PROPOSED TECHNICAL SPECIFICATION CHANGE  
FLOW REDUCTION OF 10% IN CORE SPRAY PUMP  
SURVEILLANCE REQUIREMENTS

JAMES A. FITZPATRICK NUCLEAR POWER PLANT

SAFETY EVALUATION FOR  
PROPOSED TECHNICAL SPECIFICATION CHANGE  
FLOW REDUCTION OF 10% IN CORE SPRAY PUMP  
SURVEILLANCE REQUIREMENT (JPTS-89-039)

PROPOSED TECHNICAL SPECIFICATION CHANGE  
FLOW REDUCTION OF 10% IN CORE SPRAY PUMP  
SURVEILLANCE REQUIREMENTS  
MARKUP OF TECHNICAL SPECIFICATION PAGES

## 4.5 BASES

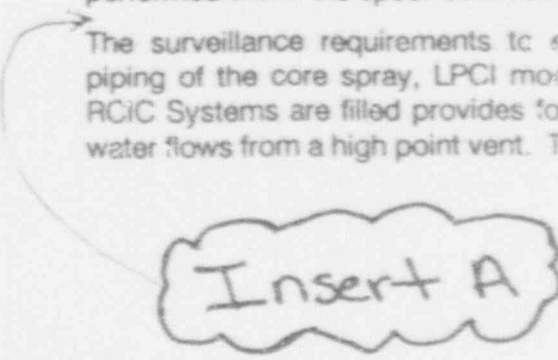
Insert A

The RCIC flow rate is described in the UFSAR. The flow rates to be delivered to the reactor core for HPCI, the LPCI mode of RHR, and CS are based on the SAFER/GESTR LOCA analysis. The flow rates for the LPCI mode of RHR and CS are modified by a 10 percent reduction from the SAFER/GESTR LOCA analysis. The reductions are based on a sensitivity analysis (General Electric MDE-83-0786) performed for the parameters used in the SAFER/GESTR analysis.

The CS surveillance requirement includes an allowance for system leakage in addition to the flow rate required to be delivered to the reactor core. The leak rate from the core spray piping inside the reactor but outside the core shroud is assumed in the UFSAR and includes a known loss of less than 20 gpm from the 1/4 inch diameter vent hole in the core spray T-box connection in each of the loops, and in the B loop, a potential additional loss of less than 40 gpm from a clamshell repair whose structural weld covers only 5/6 of the circumference of the pipe. Both of these identified sources of leakage occur in the space between the reactor vessel wall and the core shroud. Therefore flow lost through these leak sources does not contribute to core cooling.
